CITY OF FRANKLIN
PLAN COMMISSION MEETING*
FRANKLIN CITY HALL COUNCIL CHAMBERS
9229 W. LOOMIS ROAD, FRANKLIN, WISCONSIN
AGENDA
THURSDAY, FEBRUARY 20, 2020, 7:00 P.M.

REPORT TO THE PLAN COMMISSION

Project Name:	Spiegl Special Use
General Project Location:	9323 West Puetz Road
Property Owner:	Kevin M. Spiegl and Sondra J. Spiegl
Applicant:	Kevin M. Spiegl and Sondra J. Spiegl
Agent:	Matt Trenkle
Current Zoning:	R-8 / FW
2025 Comprehensive Plan:	Residential - Multifamily
Use of Surrounding Properties:	Single-family residential (R-8) to the south, east and west, and vacant lots zoned as Planned Development Districts 31 and 36, and Floodway FW.
Applicant's Action Requested:	Approval of Special Use to allow for additions to an existing single family dwelling.

Staff comments are as follows for Special Use application submitted on December 23, 2019, to allow for improvements to an existing single-family dwelling, including: interior remodeling, an addition to the second floor, an attached garage and ancillary work.

C-1.0

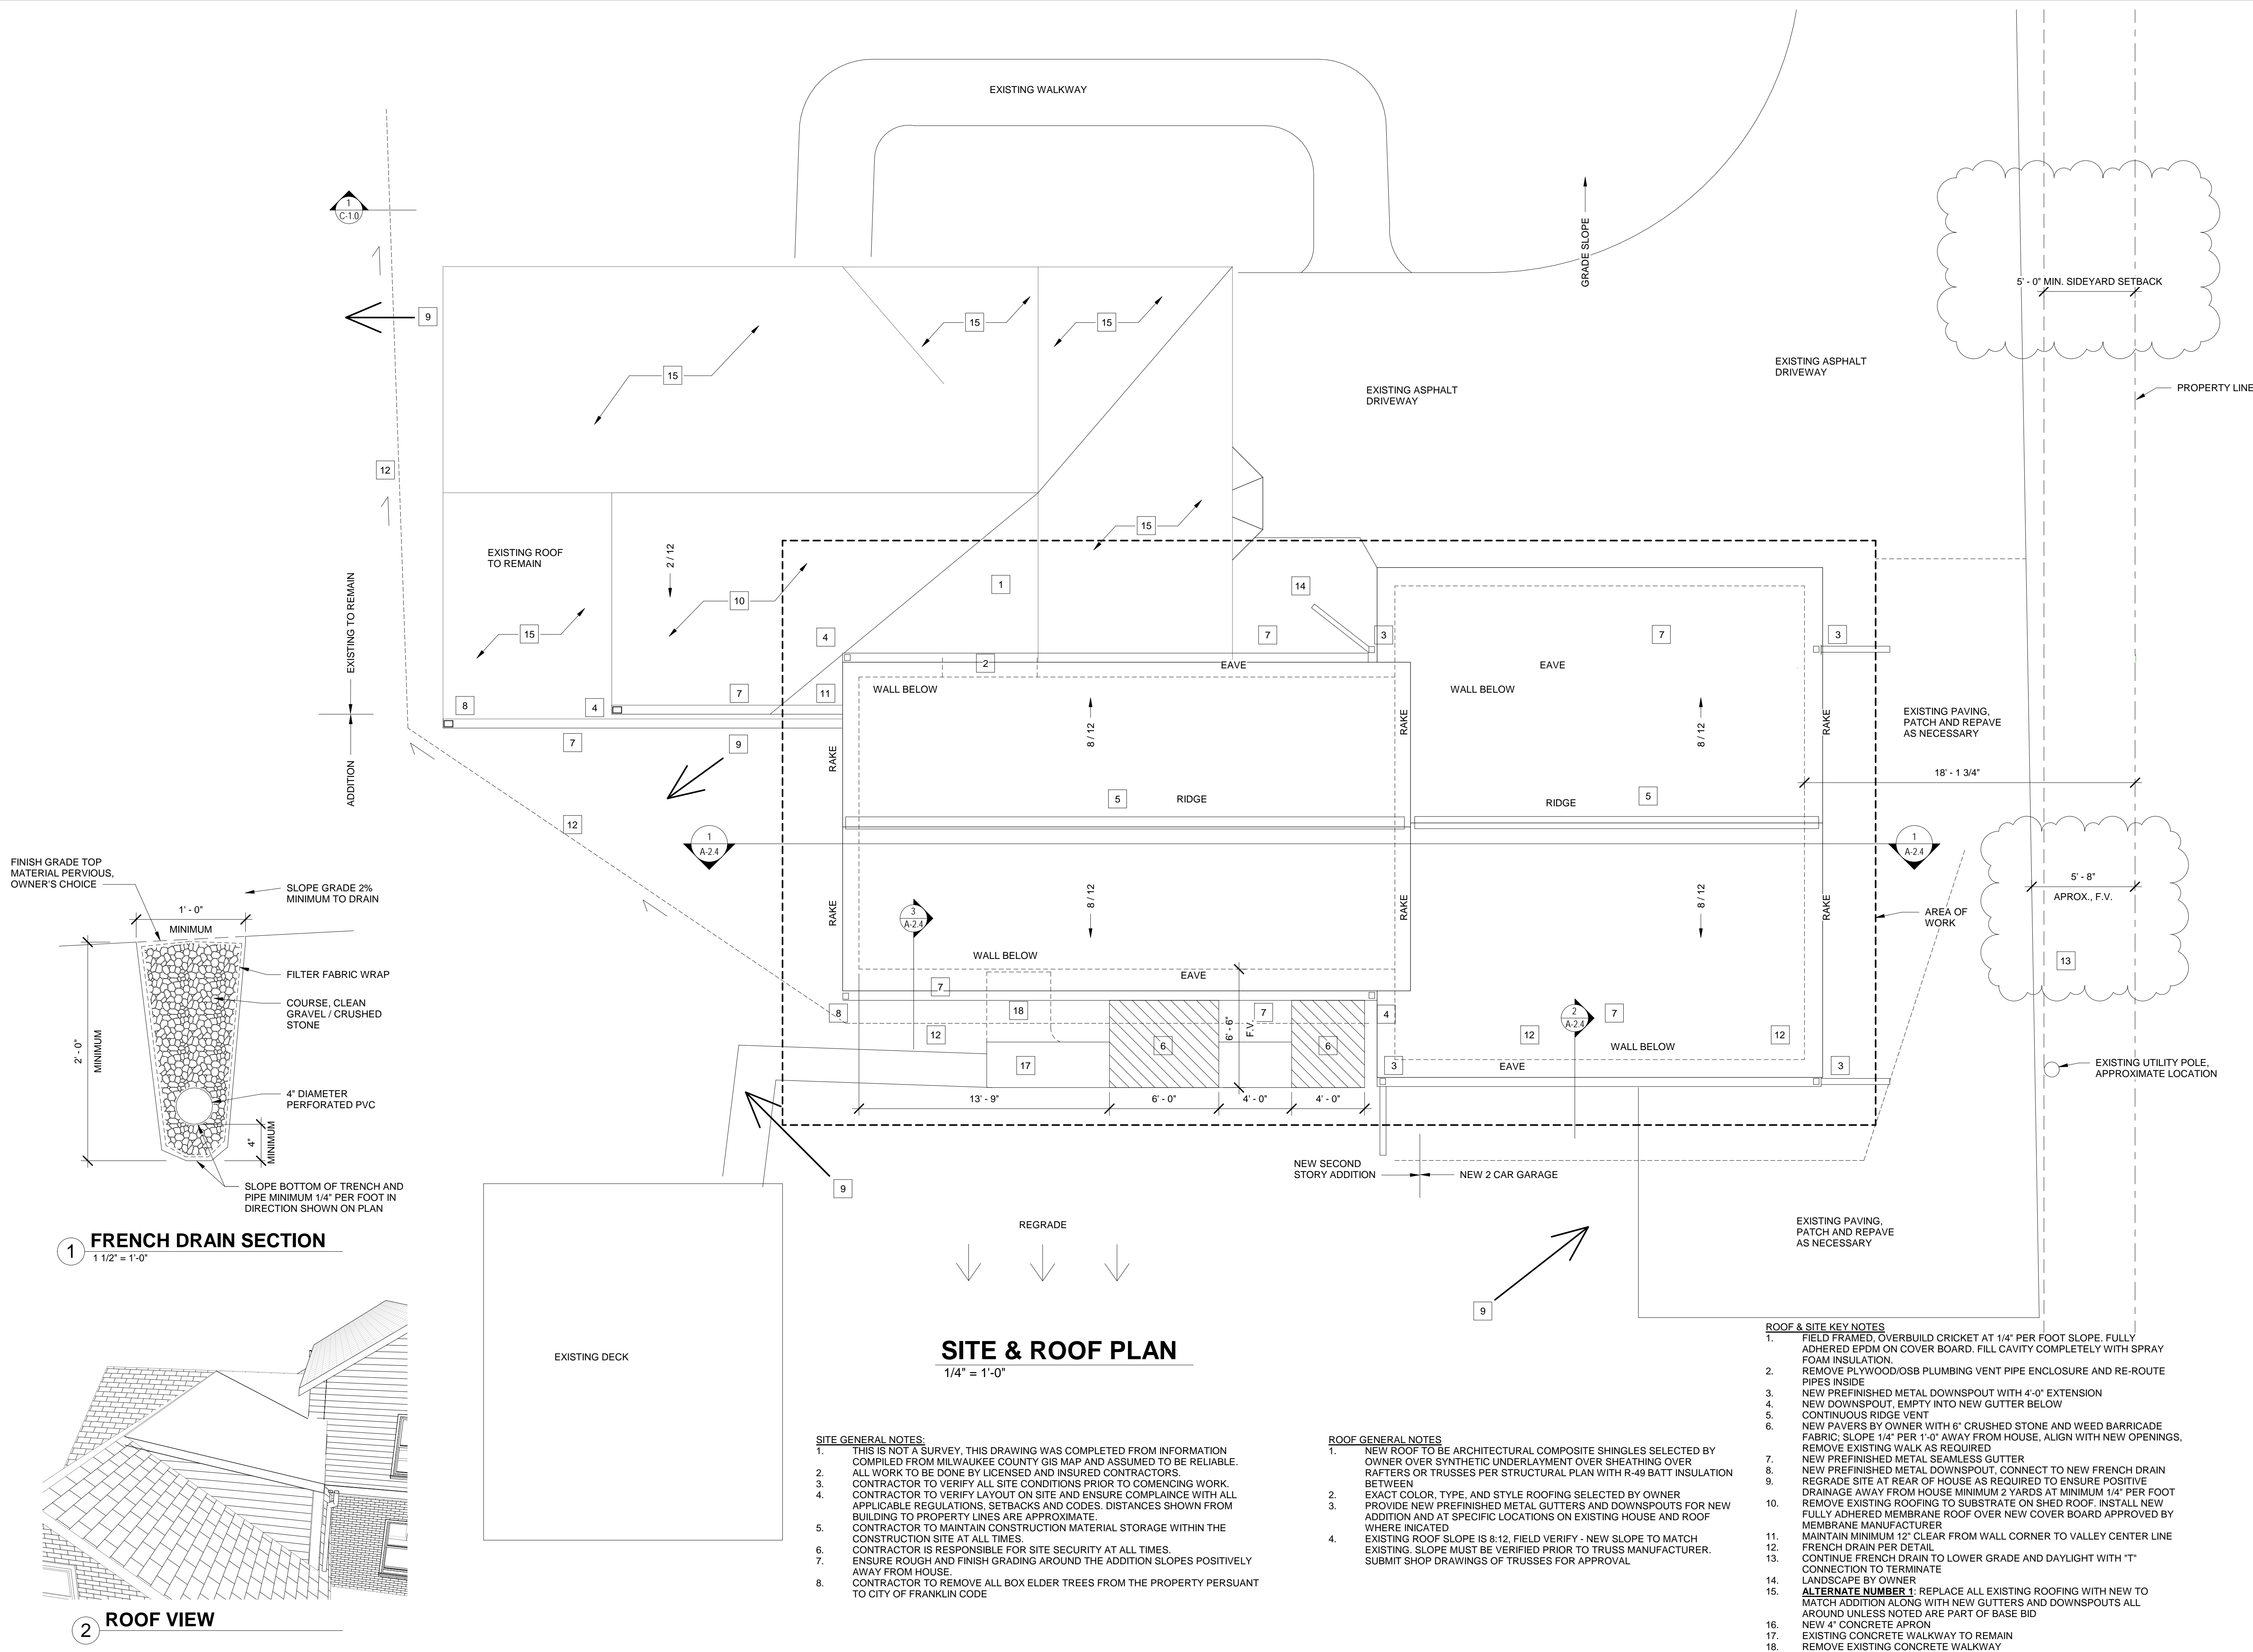
1. Sheet C-1.0 depicts an 8-foot building side yard setback. Per Unified Development Ordinance (UDO) Table 15-3.0209A, the minimum building side yard setback is 5 feet, please revise accordingly.

3. Pursuant to UDO Section 15-5.0207, driveways shall be located at least 6 feet from lot lines. Please add dimension measured from the edge of the driveway to lot lines.

- c. The proposed garage addition widened on site by a total of 9'
2. Sheet C1.0 – Site / Roof Plan
 - a. Side setback line was revised to 5'
 - b. Dimension for the sideyard setback line was revised

- c. Dimensions measuring the edge of the existing driveway distance from the property line were added.
 - d. A note requiring contractors to remove Box Elder Trees from the site was added

- e. The proposed garage addition widened on site by a total of 9', 4.5' to the north and 4.5' to the south
3. Plat of Survey by Continental Surveying
 - a. Proposed addition is now shown on the plan and dimensioned
